# CDC-INSTALLATION (1) PC - MODULAR BUILDING (40'X48') & (2) - PC SHADE STRUCTURES (30'X30')

ADDENDUM 01

**CHILD DEVELOPMENT CENTER - FIRE WATER LINE EXTENSION AND FIRE HYDRANT**

ADDENDUM 01 - ADDED SHEET

SITE PLAN

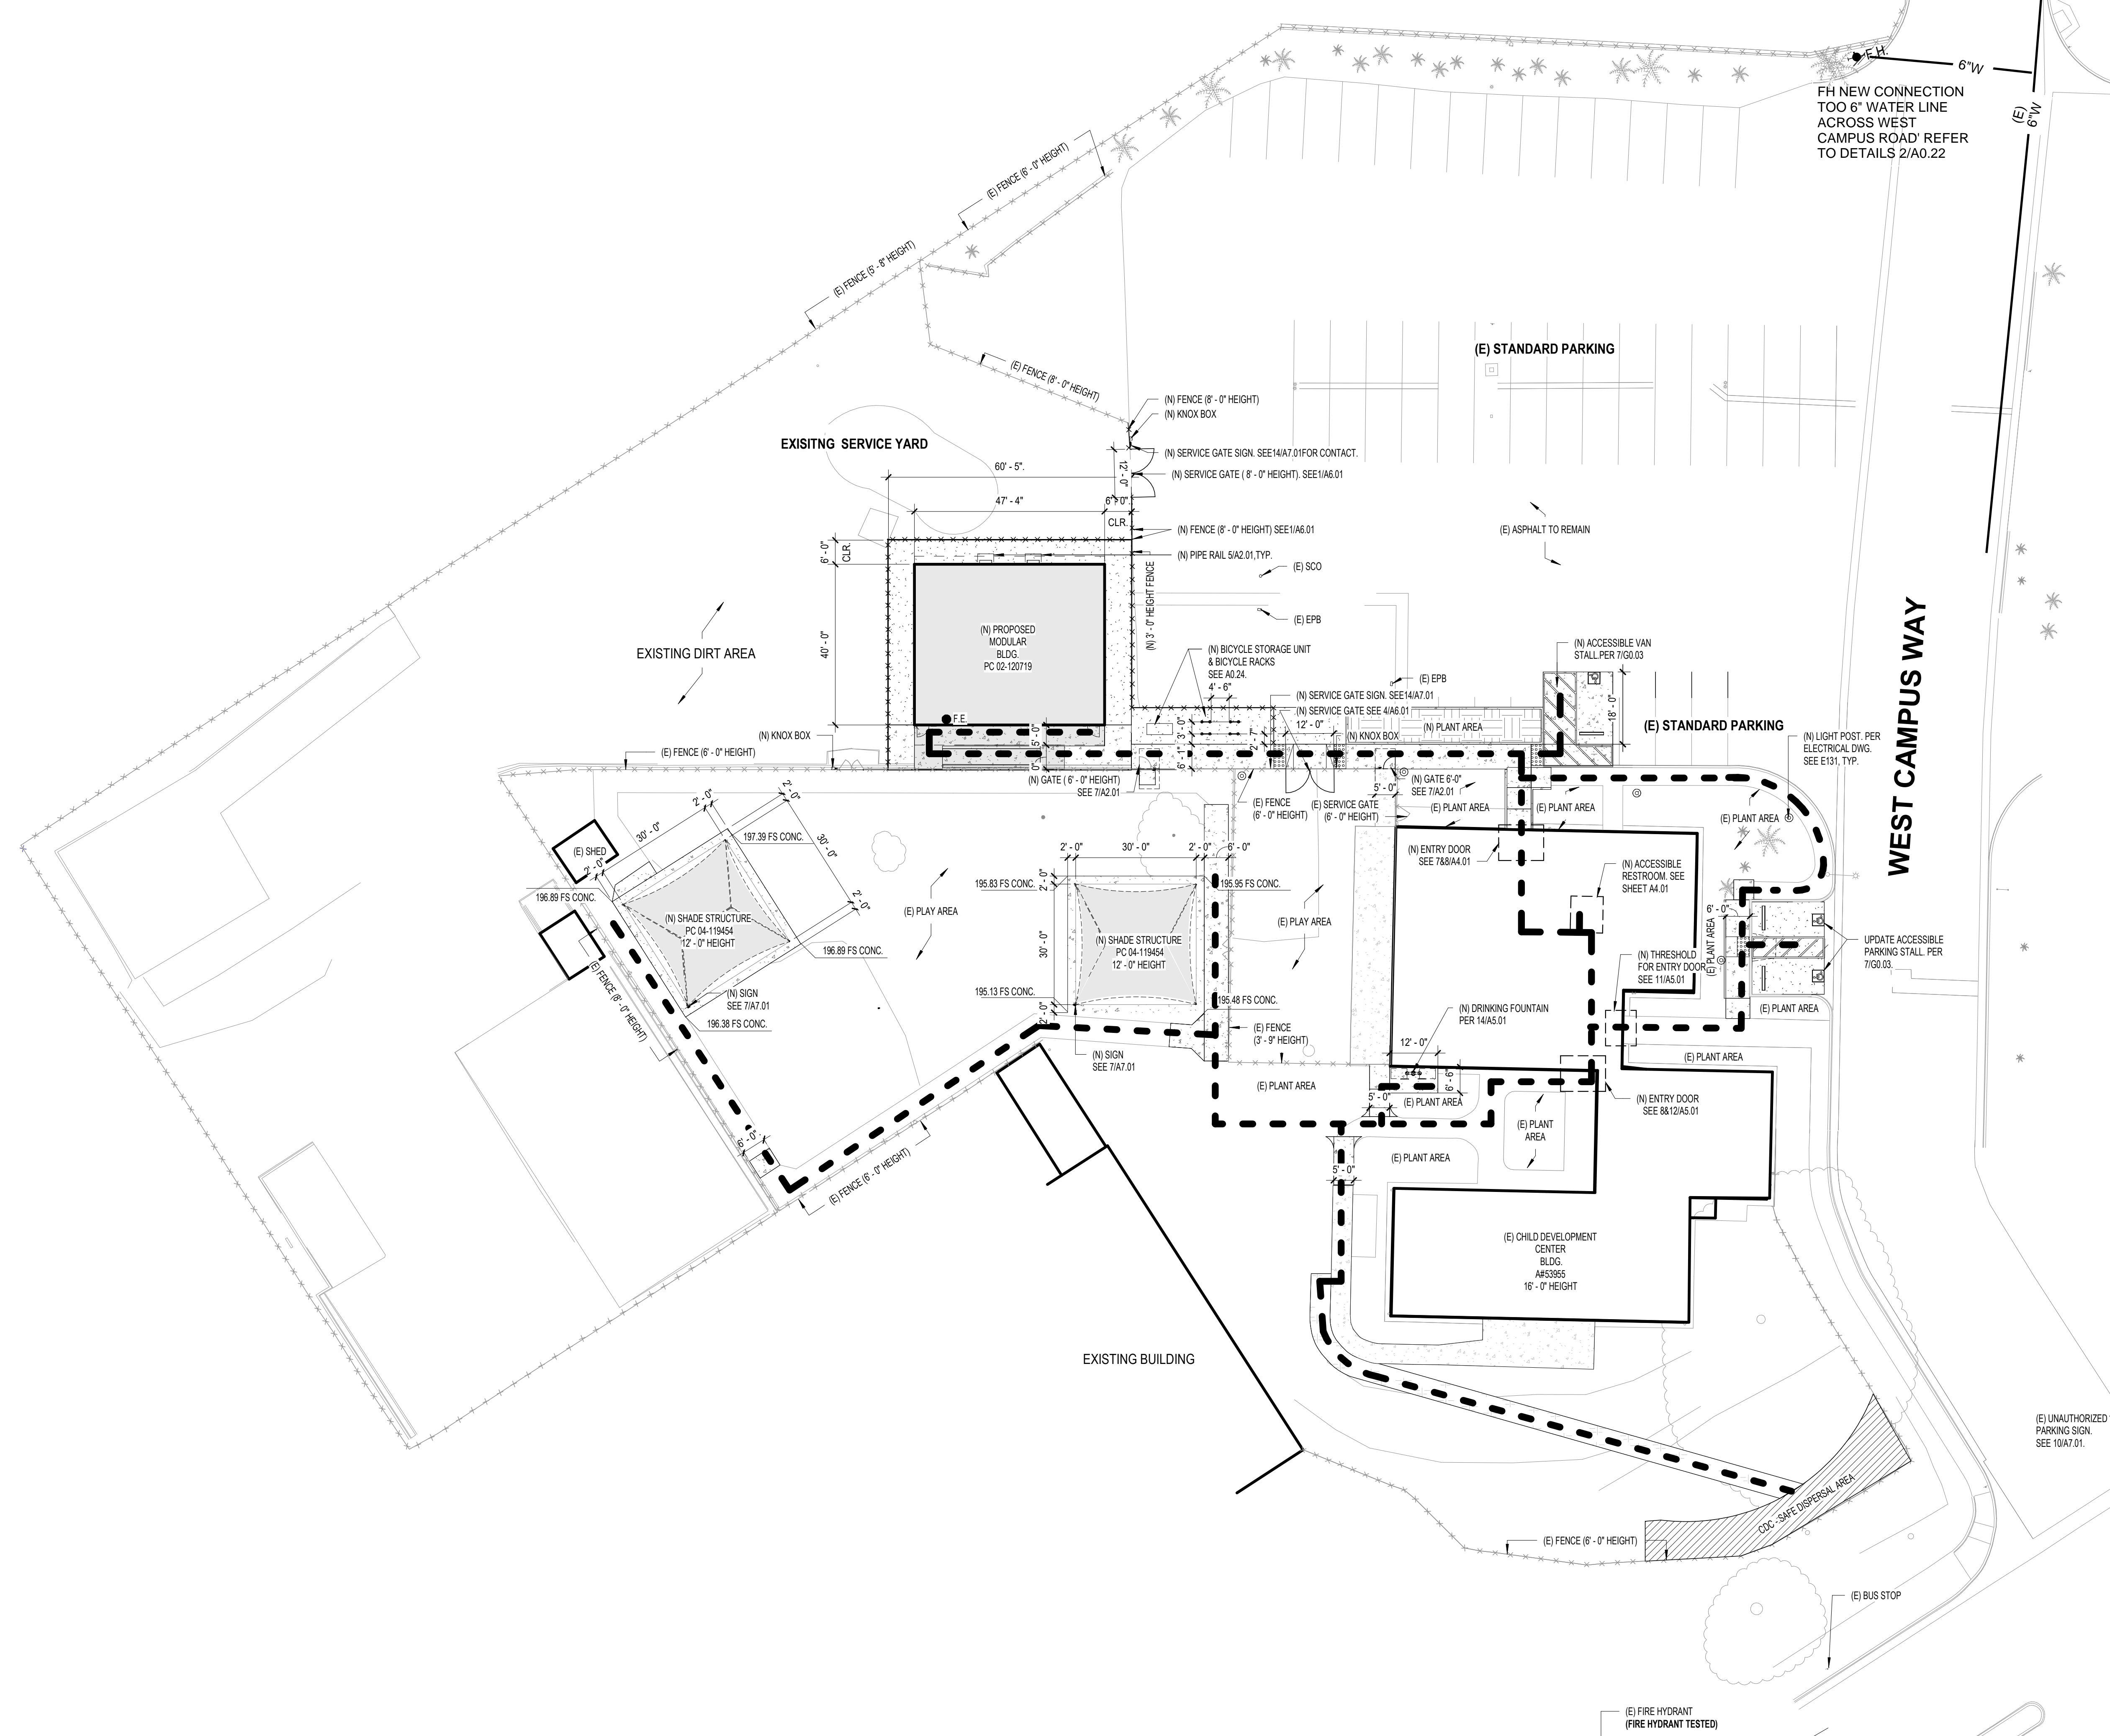
NEW FIRE HYDRANT DETAILS ADDENDUM 01-REFER TO UPDATED SHEETS C3.00 & C4.00
